## REMARKS:

Claims 1 through 18 have been cancelled. Claims 19 through 43 have been added. Applicant has enclosed substitute drawings of figures 2A, 3A, 4, 11B, 11C, 19, 23, 25, 27, 29, 29A, 34A, and 38 with corrections to the examiner's objection to the drawings. In particular, the drawings were objected to as failing to include reference signs 145, 151, 187, 233, 239, 294, 602, 573, 583, 646, 465, 868, 906, and 912. These reference numbers have been added to the figures. A copy of the figures with these changes is circled in red. Reference signs 202, 264, 744, and 822 have been changed to 194, 161, 742, and 920 in the specification to be consistent with the drawings and other language of the specification.

## **VERSION WITH MARKINGS TO SHOW CHANGES MADE**

FIG-23

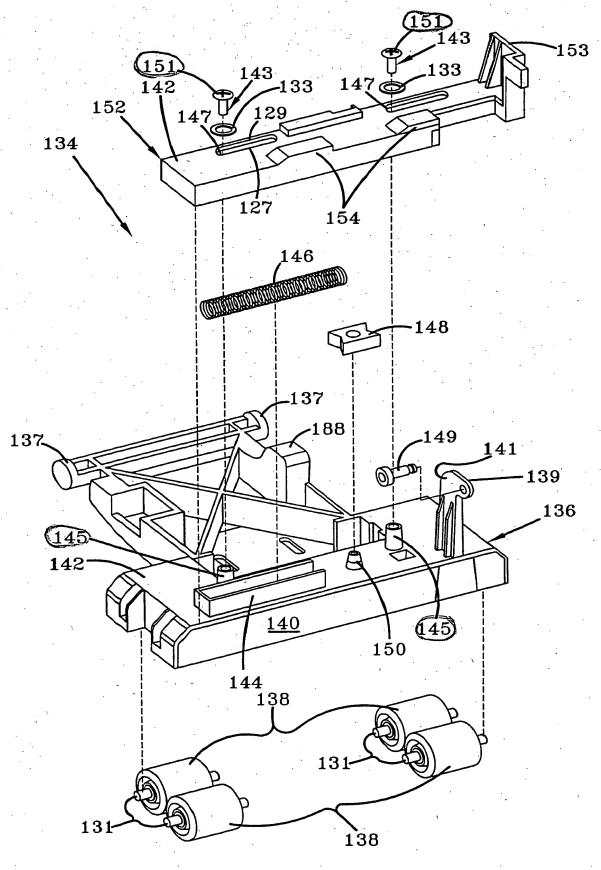
To accomplish this action as depicted in FIG. 30C, a snap pin 149 extends through the ring member 719 and <u>an</u> aperture [141 (FIG. 23)] of the upwardly extending arm 141 of the wheel carriage (FIG. 23) pivotally securing them together.

FIG-25

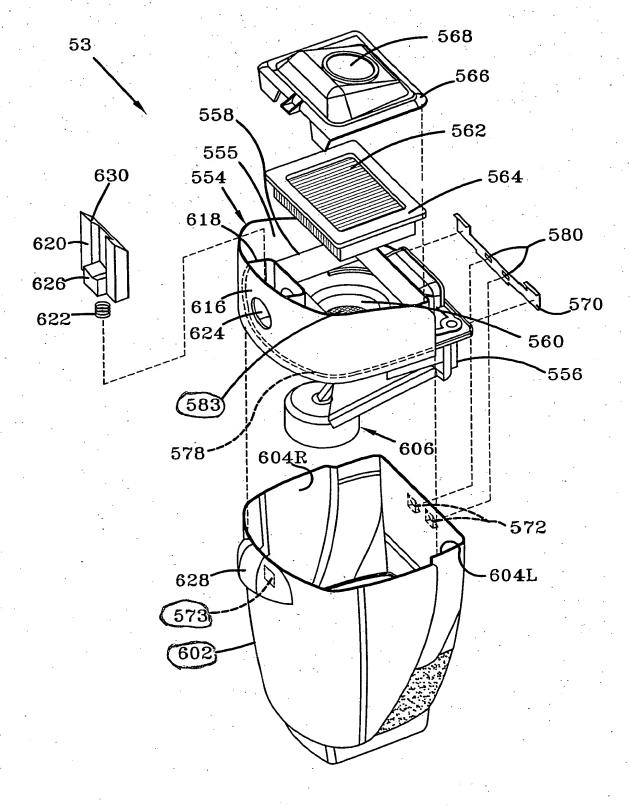
The lid 554 includes an upper [555] portion <u>555</u> mounted to a lower portion 556 with a rope seal 578 there between as also seen in FIG. 25A.

FIG-29A

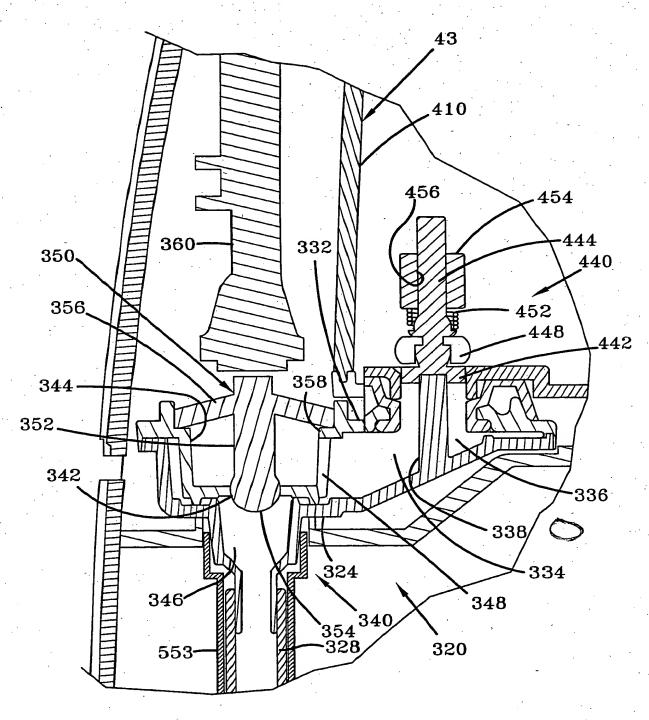
Referring now to FIG. 29A, cleaning solution reservoir assembly 320 includes a bottom concave lower basin 324 having [a] the supply tube 328 exiting therefrom.
